### CERTIFICATE OF APPROPRIATENESS

**Property:** Lot 1, Track 2A Block 145, Houston Heights West Neighborhood Subdivision. The property includes an historic 2,690 single family two and a half story residence, on a 7,250 sq. ft (55 ft. x 132 ft.) corner lot.

**Proposal:**

**Recommendation: Denial - does not satisfy criteria**

**PROPOSED WINDOWS**

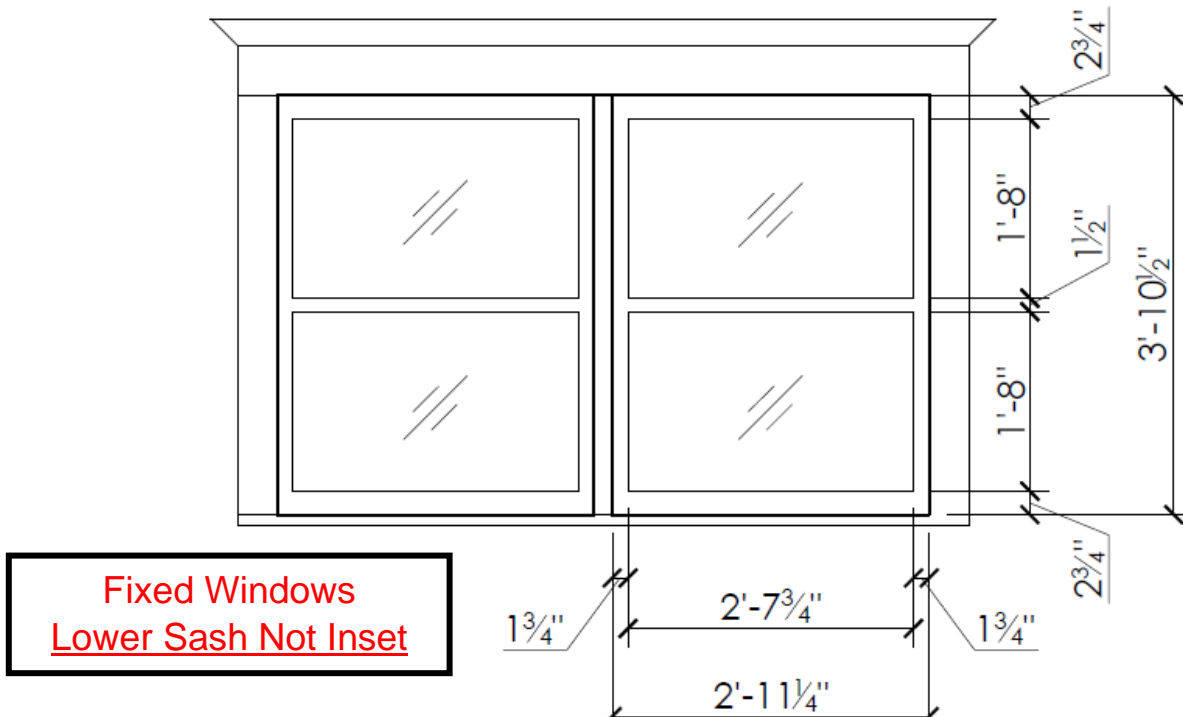
- Replacing two non-original wood single hung windows
- Windows to be two side by side fixed one-over-one lite windows with sashes, muntin's and glazing to be the same dimensions and proportions as existing.
- Lower sash will not be inset.
- No change at all to window size or location.

**ALL NEW WINDOWS MUST BE INSET 1¼ Inches – See Attachment 1  
Windows Must Be Equally Horizontally Divided 1-over-1**

- (1) The proposed activity must retain and preserve the historical character of the property; Removing windows with inset lower sash, is removing historic character from this house.

(4) The proposed activity must preserve the distinguishing qualities or character of the building, structure, object or site and its environment; Removing single-hung windows with inset lower sash is out of character with the other windows on the home and the context area.

(6) New materials to be used for any exterior feature excluding what is visible from public alleys must be visually compatible with, but not necessarily the same as, the materials being replaced in form, design, texture, dimension and scale; Proposed fixed windows without an inset lower sash is out of character for the building and the context area.
